**Re: 100% Final Technical Execution Plan for the Allied Ready Mix Bank Management Areas
Former DuPont Waynesboro Plant, Area of Concern 4
Waynesboro, Virginia
EPA ID# VAD003114832**

**Technical Execution Plan
Allied Ready Mix Property Bank Management Areas
Area of Concern 4, Former DuPont Waynesboro Site, Waynesboro, Virginia**

DOCUMENT (DATE): 90% Draft Technical Execution Plan (TEP) – Allied Ready Mix (ARM) Property Bank Management Areas (BMAs)
PRINCIPAL AUTHOR (Name, Company): AECOM for E.I. du Pont de Nemours and Company
HDR Contract No.: EP2060743

CRITICAL SLOPE-STABILIZATION CROSS SECTION

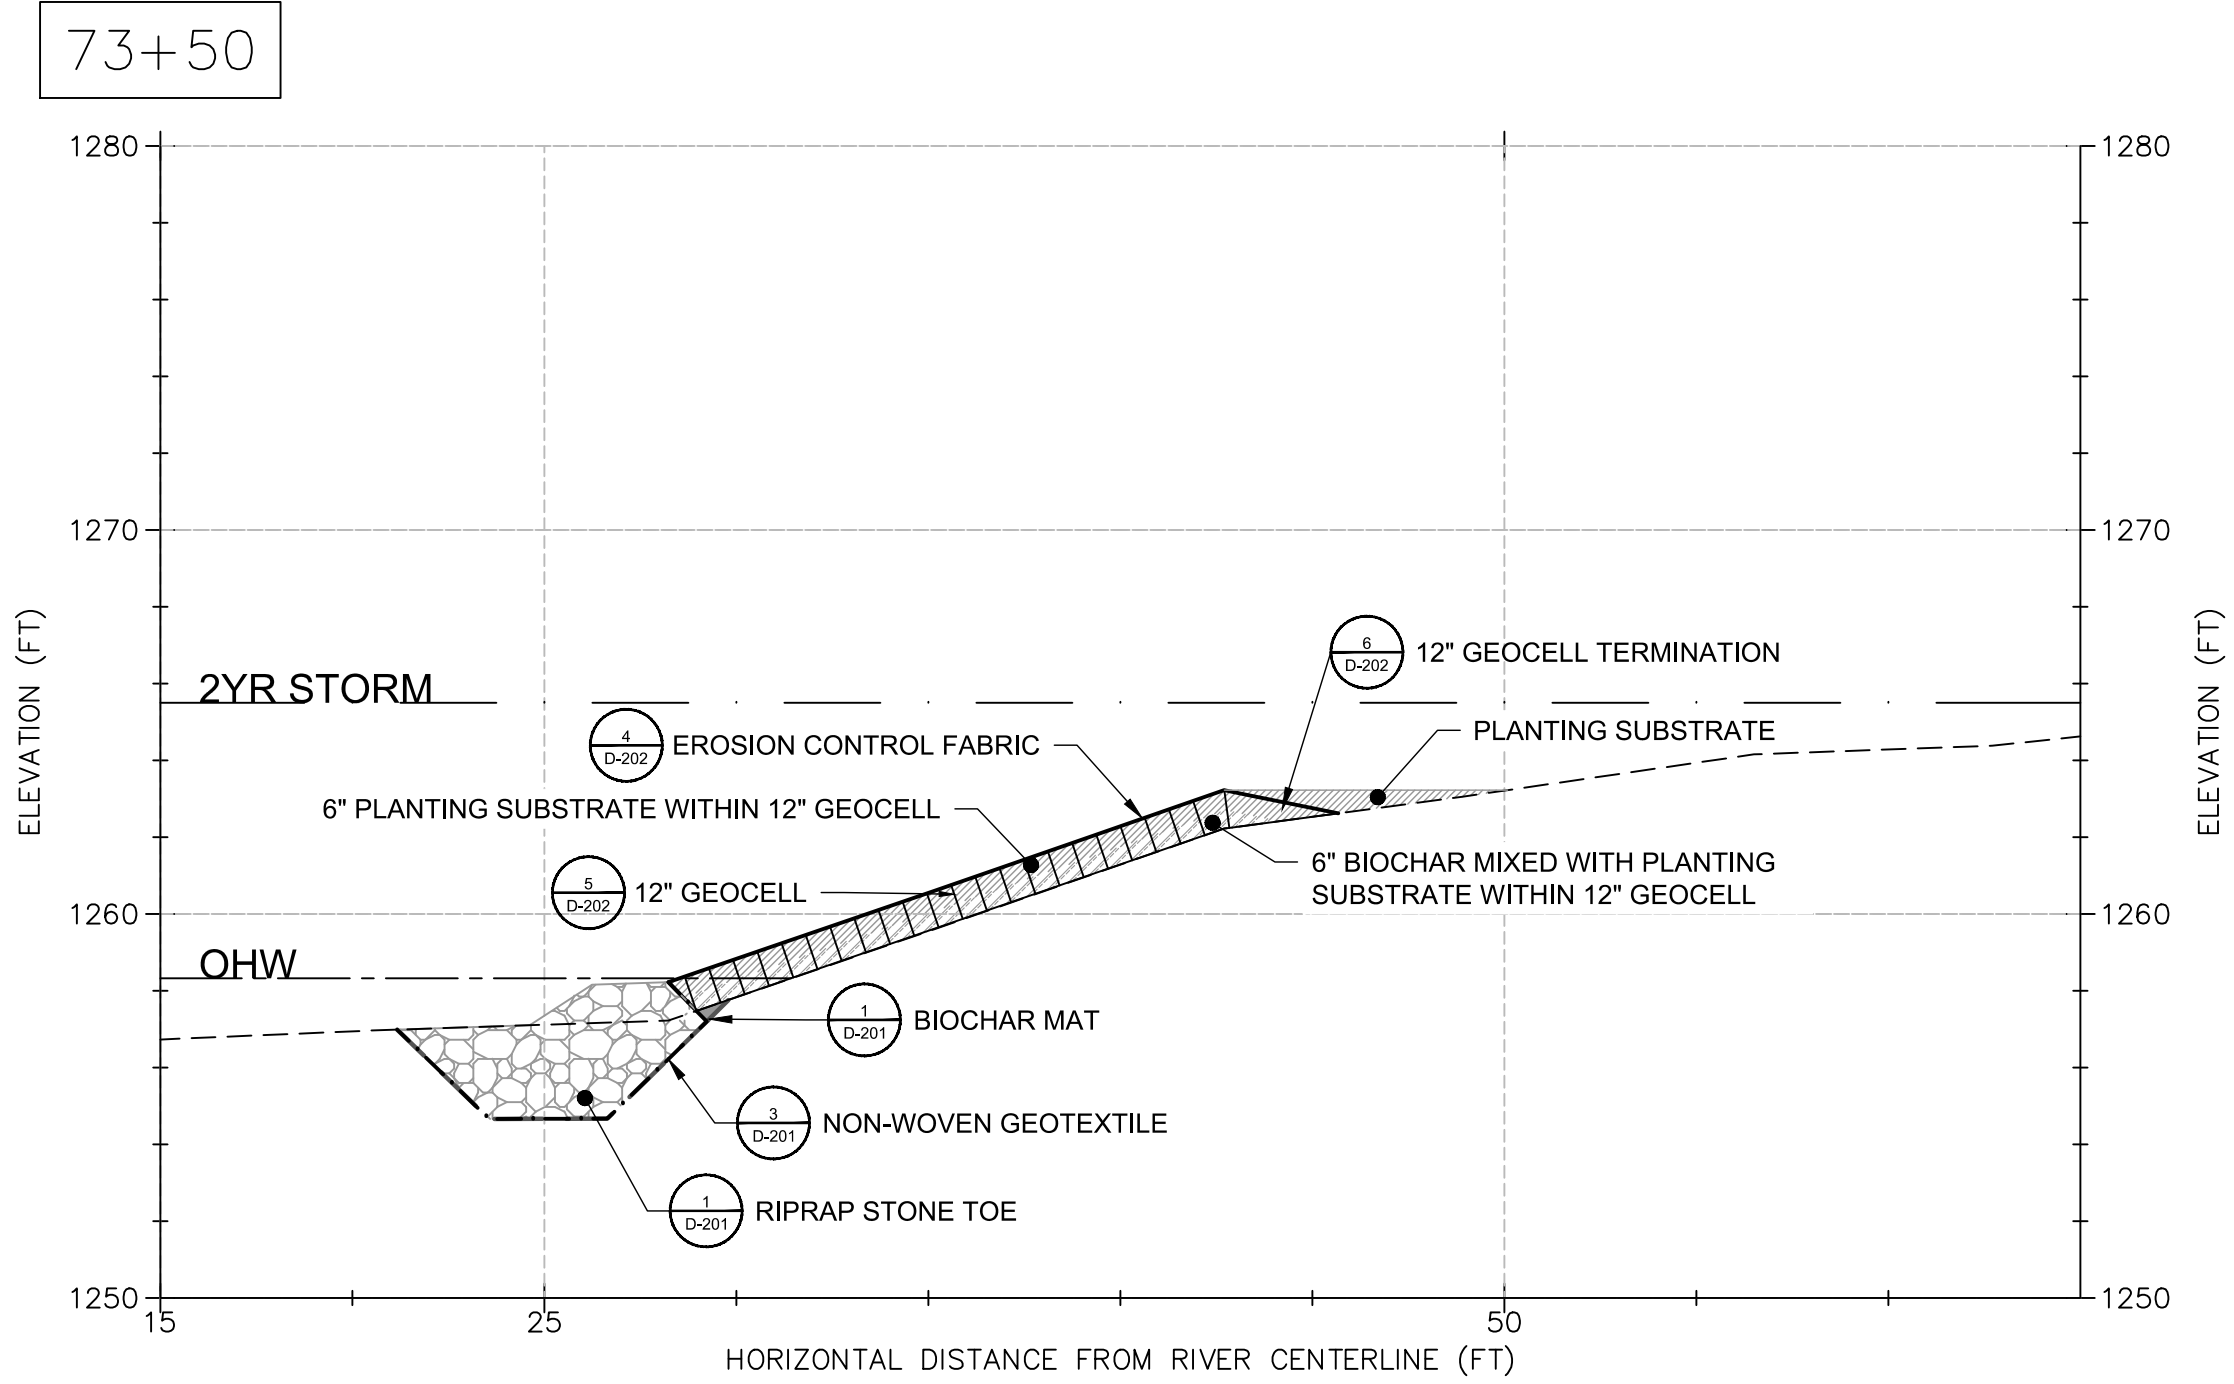
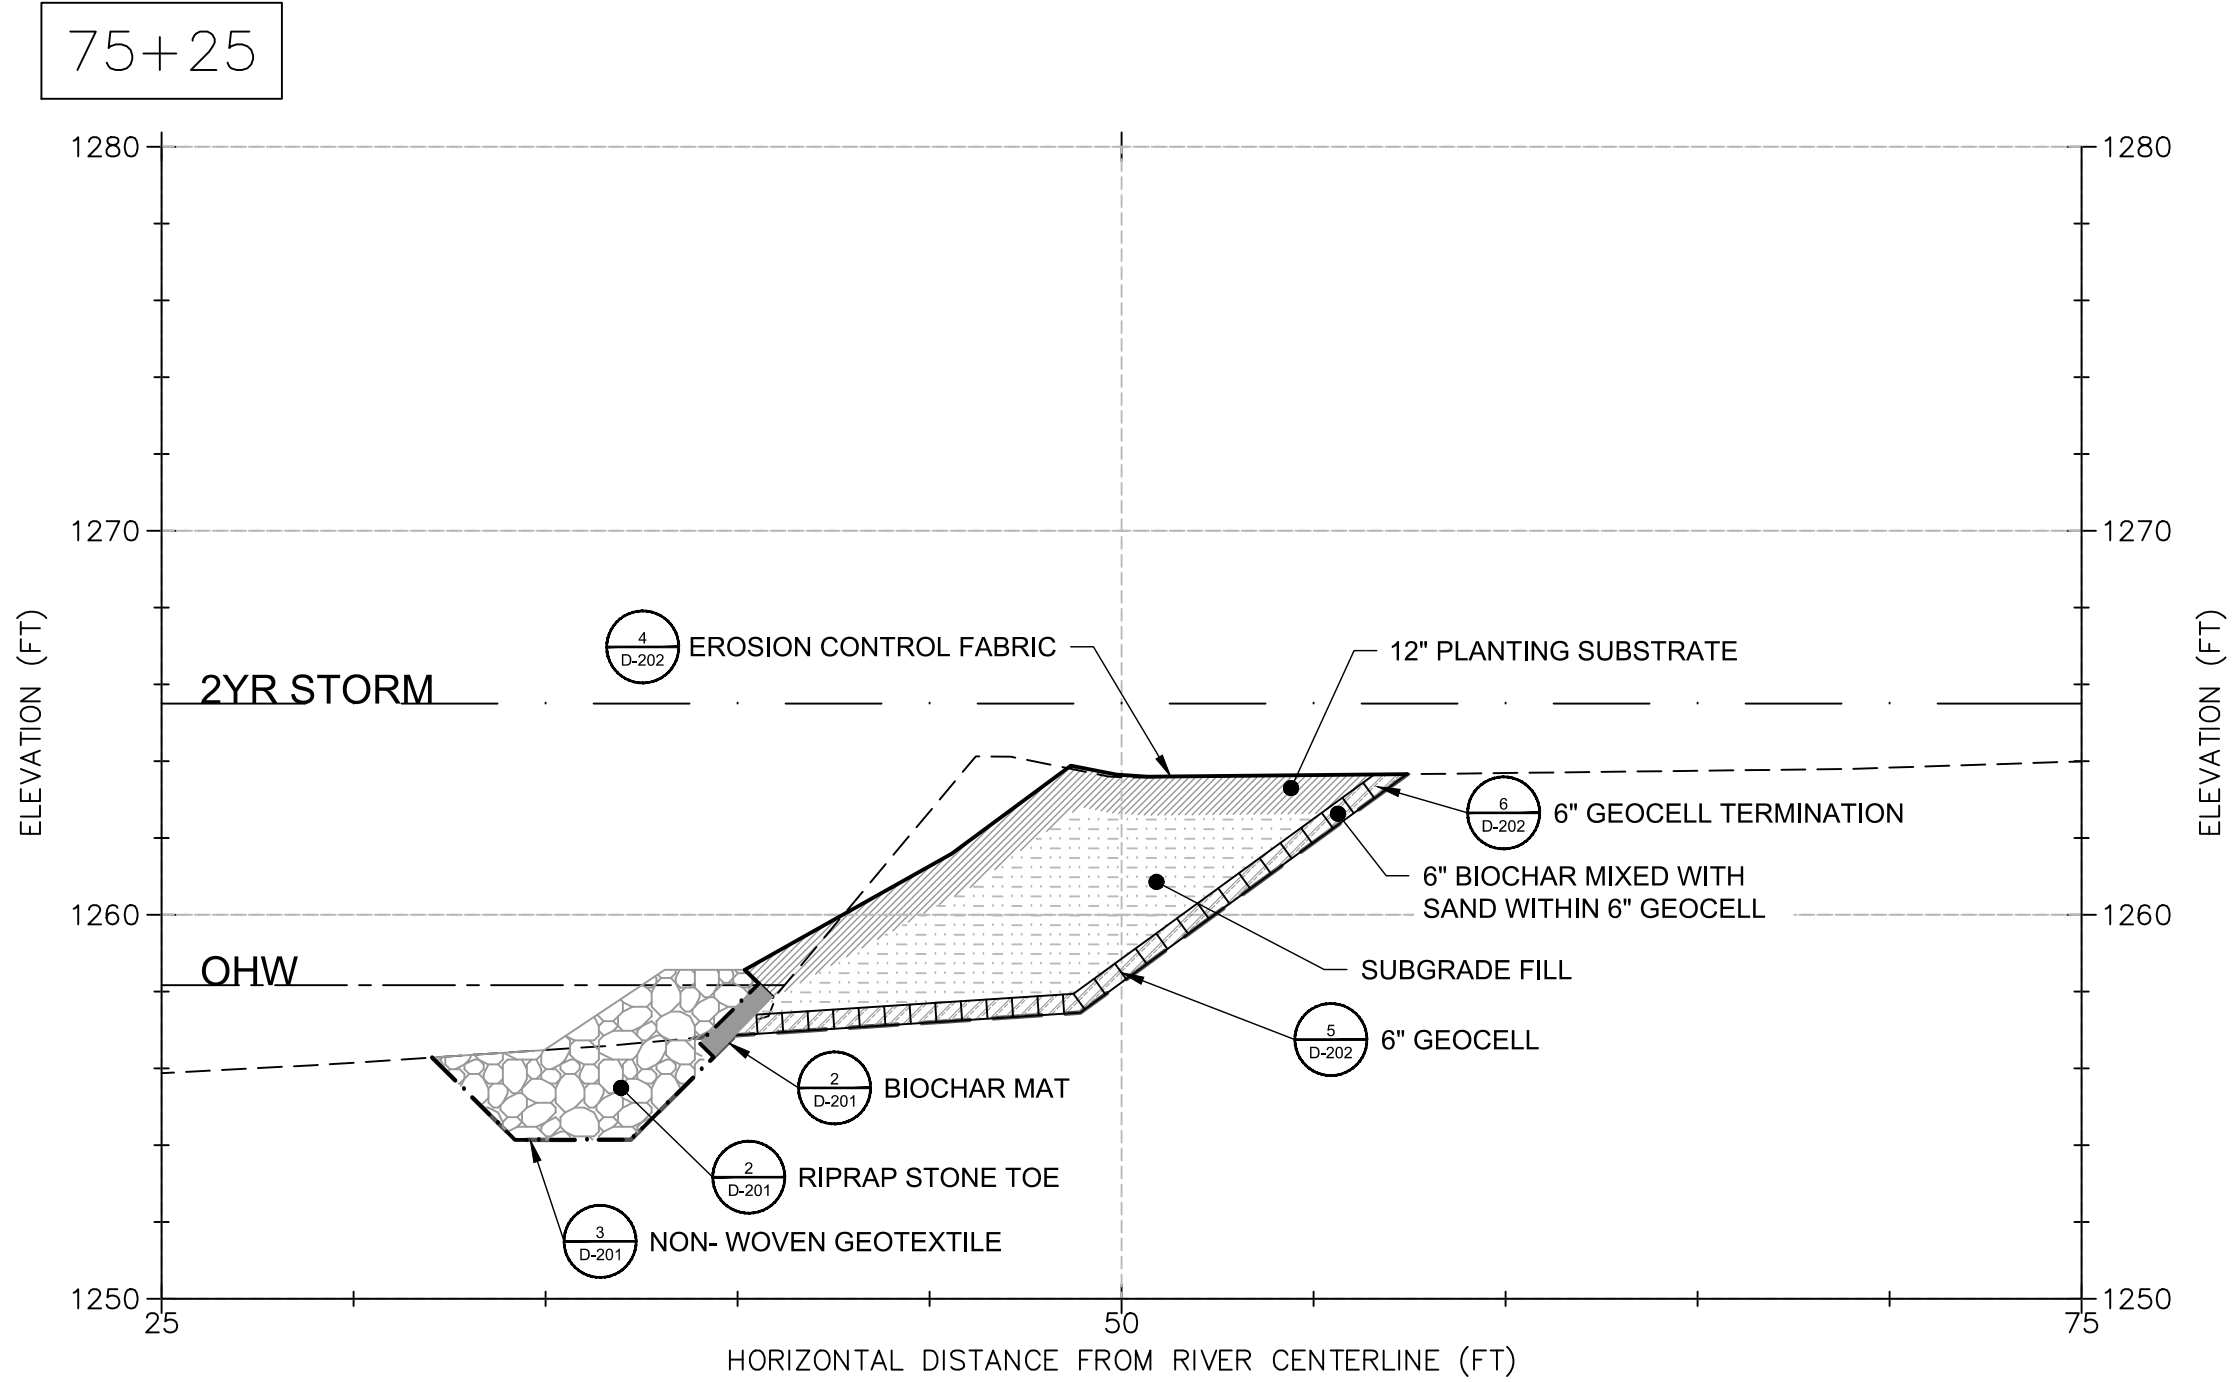
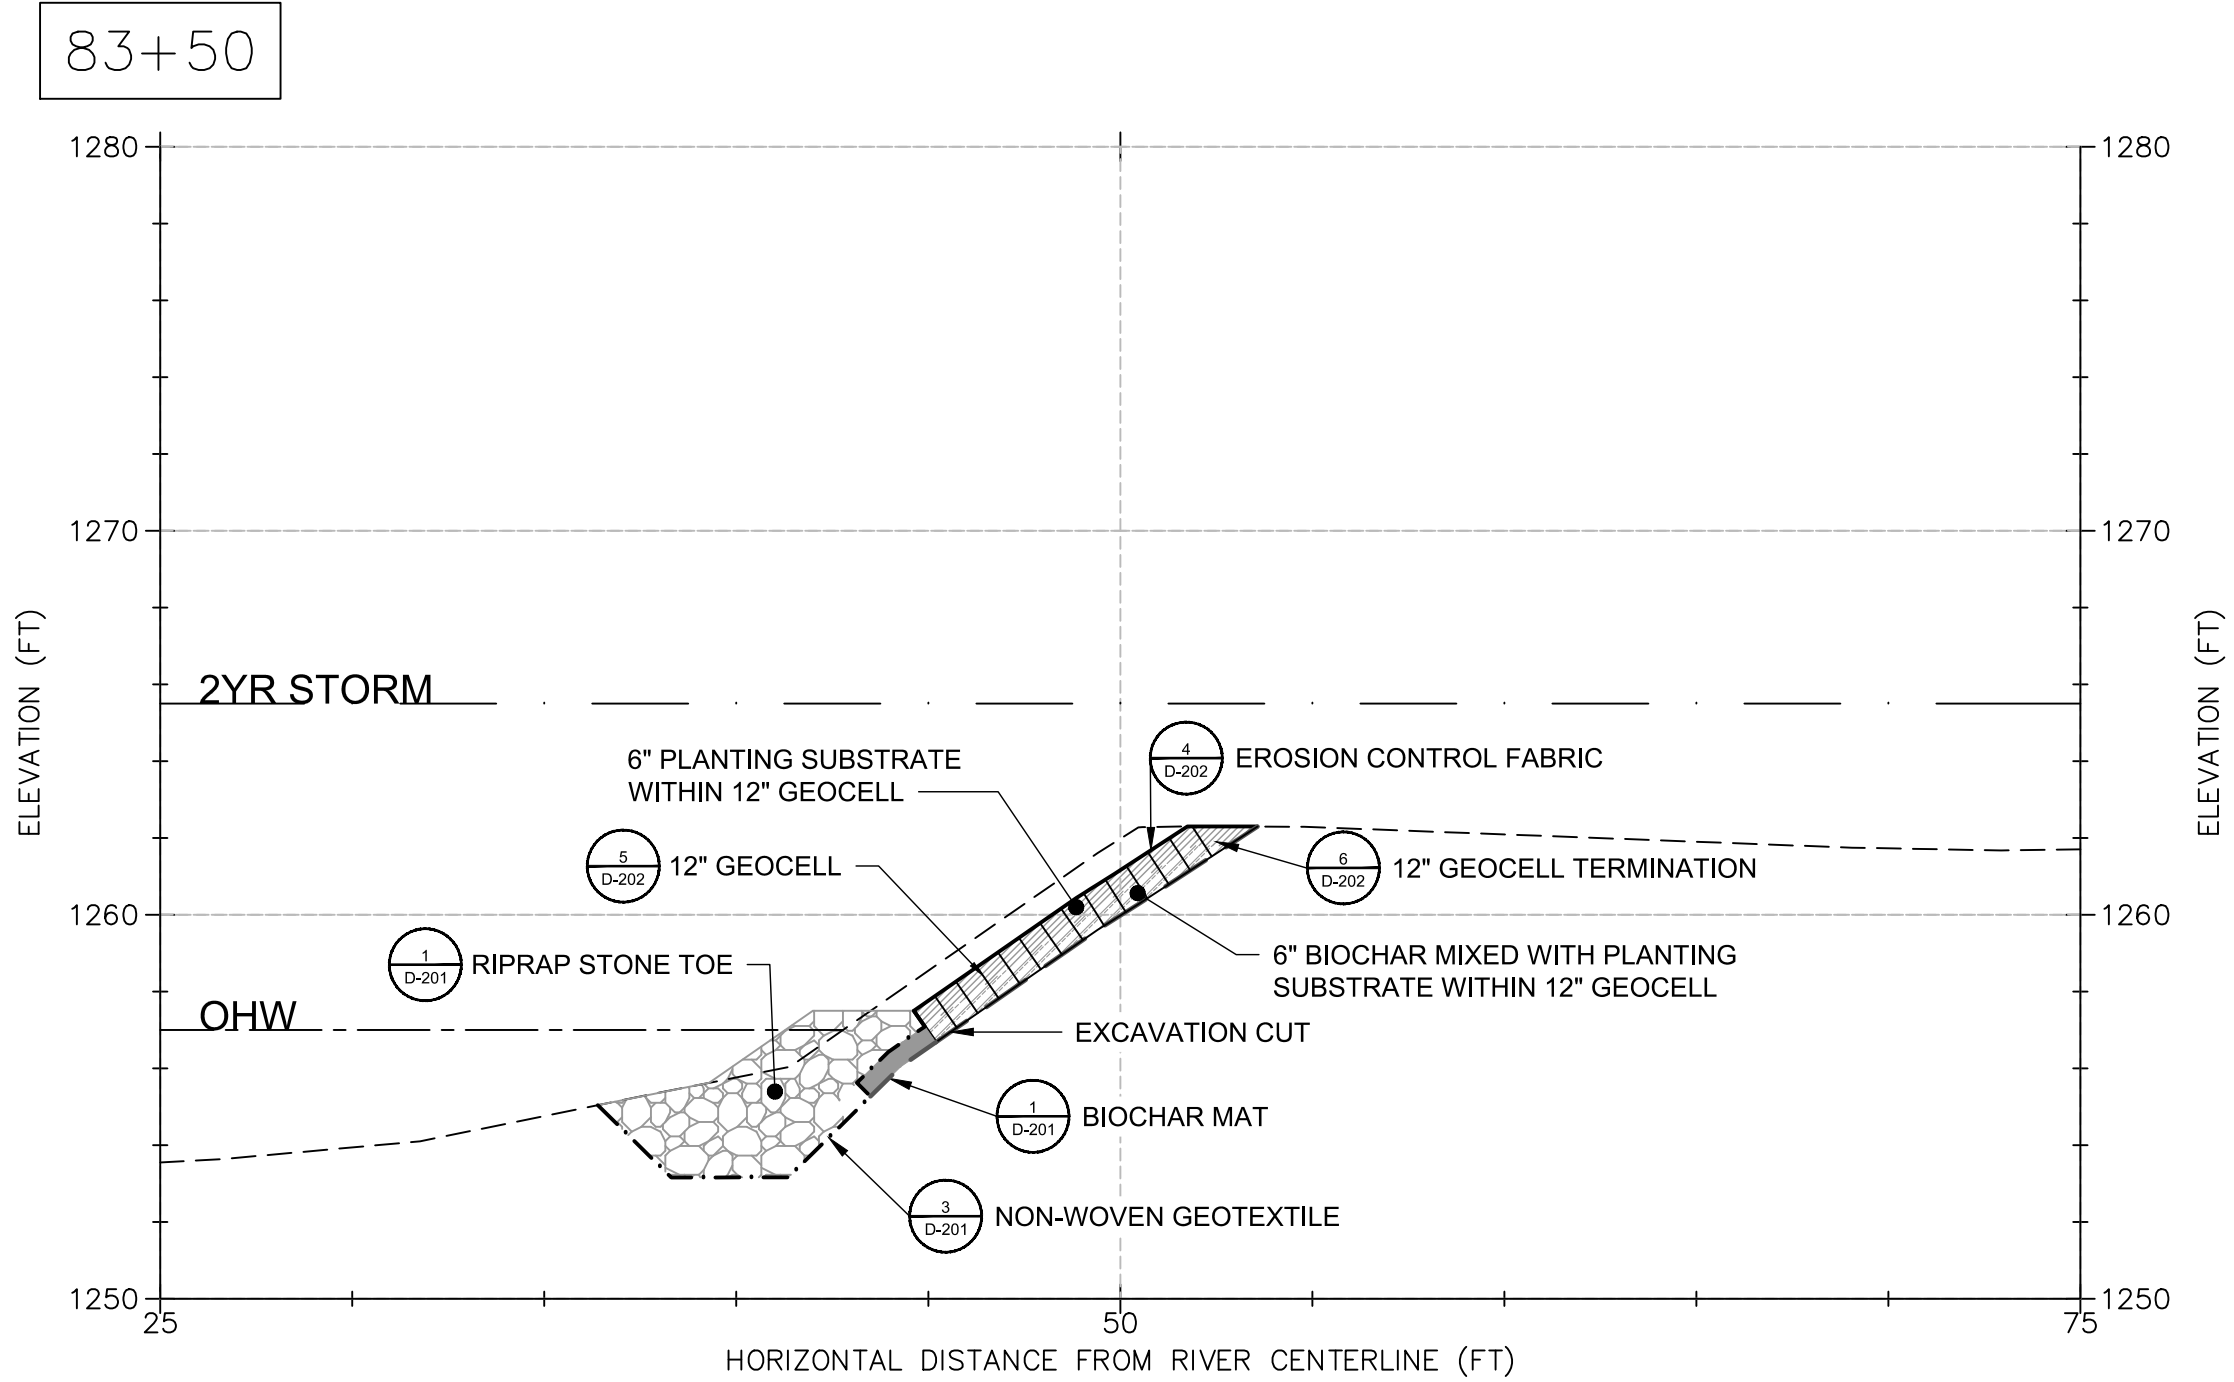
8	Pg 10, Section 3.4.1 Paragraph 7	The text states “The 6-inch biochar layer will extend 6 inches above the OHWM...” In the typical detail it appears that the biochar layer will extend to the top of the bank unless the detail is incorrect and should show limits of the biochar backfill separate from the sand.	The referenced text has been revised to “The 6-inch biochar layer will extend up to the 2-year storm elevation or to the top of bank termination, whichever is reached first.”	
9	Pg 10, Section 3.4.1 Paragraph 7	What is the rationale for incorporating biochar filled socks in this design?	Biochar mats have replaced biochar-filled socks in the restoration design. Biochar mats on the bank beneath the stone toe would provide treatment of water that exchanges with the river at this elevation range during storm events. The biochar-filled geocells and the biochar mats together provide water treatment over the full range of elevations where water exchange through the bank is likely to occur.
